付属資料 9: Pre-F/S レビュー・レポート(斜張橋)

パナマ首都圏都市交通(3号線)
整備事業準備調査

(第4パナマ運河橋整備事業)

Pre-F/S レビュー・レポート
(斜張橋)

図 3.5 主橋断面

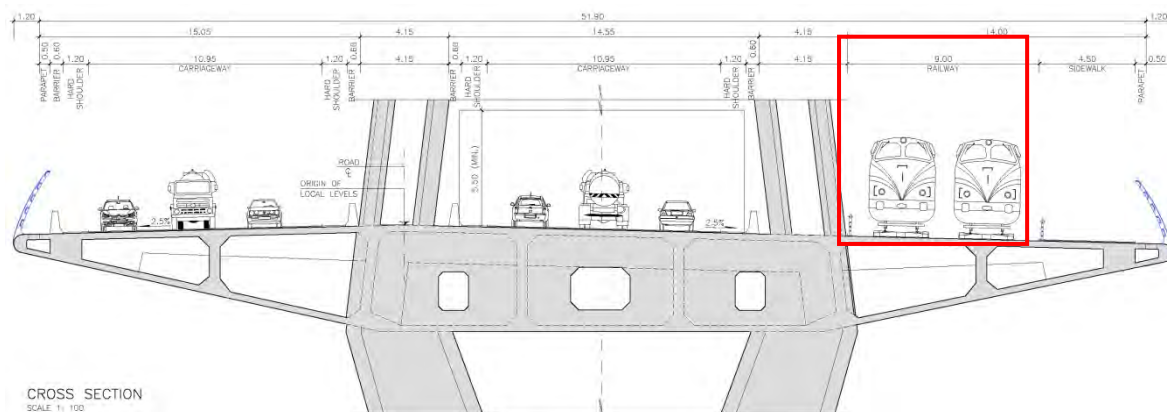
コンセプトデザインレポートの冒頭で、片側配置におけるアプローチ部でのメリットを以下のように述べている。

- 道路と鉄道との交差が生じないため、交差の際に生じる特別な構造的な対処は必要ない
- 道路部分を一つの橋脚に集約できるため、橋脚の数を3つから2つに減らせる
- 構造的に統一感が図れるため、景観的にも優れた構造となる

本調査におけるモノレールの配置は、比較検討を行いメトロ庁との調整を踏まえて南側としている。軌道の配置は北側と南側とで異なるが、対象となる主橋区間では同じ橋面上に配置されているため、比較の際は同条件として取り扱う。

なお、軌道の占有幅については Pre-F/S 案のメトロニアが 9m、本調査案のモノレールが 8.4m としているため、比較の際はモノレールで統一するために、Pre-F/S の幅員マイナス 0.6m の補正を加えるものとする。

図 3.8 応答スペクトル

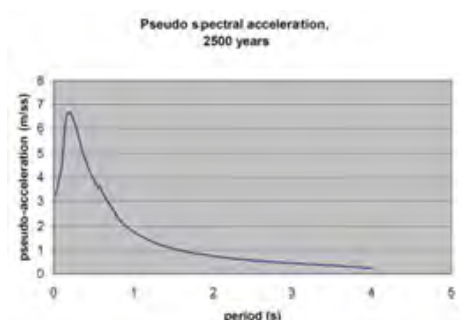
地震応答スペクトルは、Pre-F/S レポートのものが、ASCE(AMERICAN SOCIETY OF CIVILENGINEERS)でのスペクトル形状を用いている。しかしながら、これから地震時荷重をどうやって算定したかについてはレポートに記載されておらず、確認することができなかった。

本調査においては、第2橋(センテナリオ橋)を設計する際に行った調査(「SEISMIC HAZARD ASSESSMENT OF THE SECOND PANAMA CANAL CROSSING」)での調査結果を用いることで 運河庁(ACP)及びメトロ庁(SMP)と合意した。しかしながら、形状としては、両者とも似た形状を示している。設計水平震度については、Pre-F/S の地震荷重を分析し同等の地震荷重を採用しているため、比較の際は同条件として取り扱う。

図 5.1 構造設計モデル

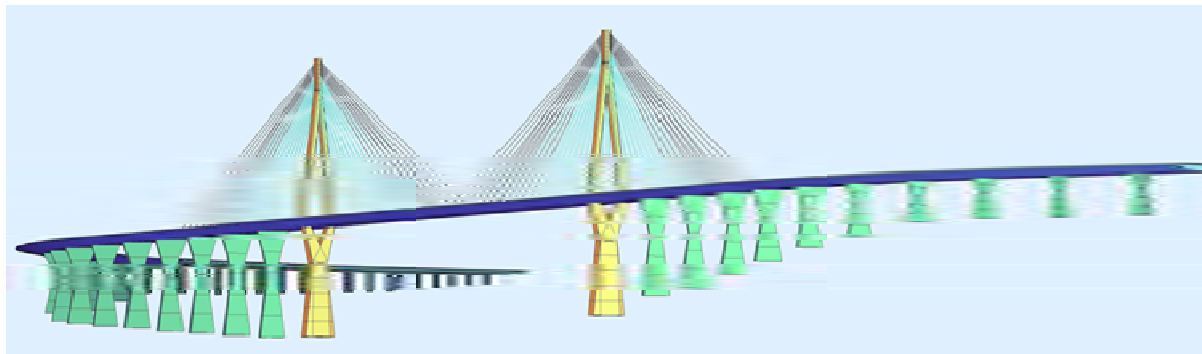
全体モデルで解析が行われているが、モデル図・入力データのみが添付されている。

モデル図および入力データは確認されたが、解析結果および断面計算結果が添付されていないために確認できなかった。

Pre-F/S の構造解析は適切であると想定し、比較の際は同条件として取り扱う。

図 5.2 構造設計モデル

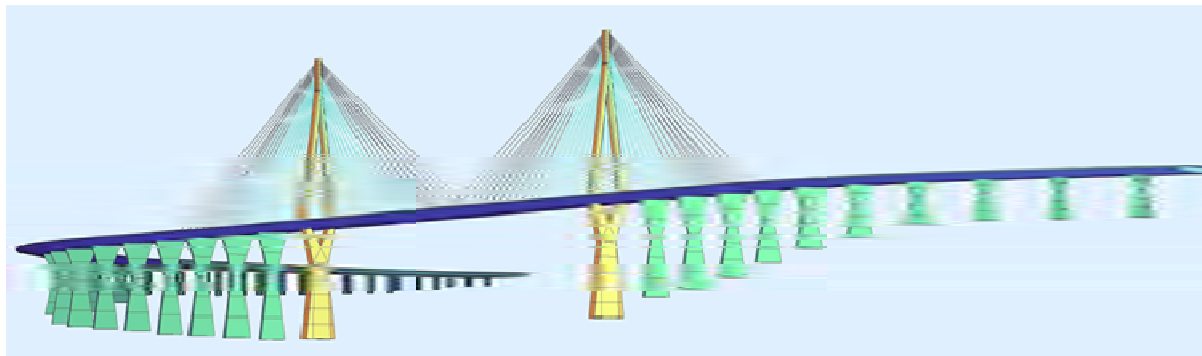
全体モデルで解析が行われているが、モデル図・入力データのみが添付されている。

モデル図および入力データのみが添付されており、解析結果および断面計算結果が添付されていないため、検証ができない。

Pre-F/S は計画・設計条件から適切に解析がなされていると想定し、比較の際は同条件として取り扱う。

図 5.4 固有値解析結果

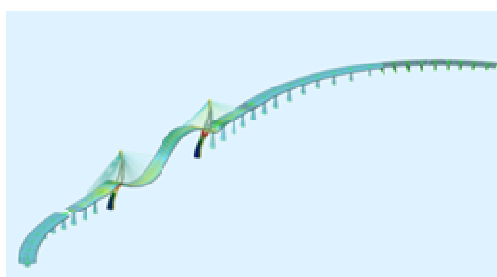
地震時においては、大きな変異が生じていると考えられる。
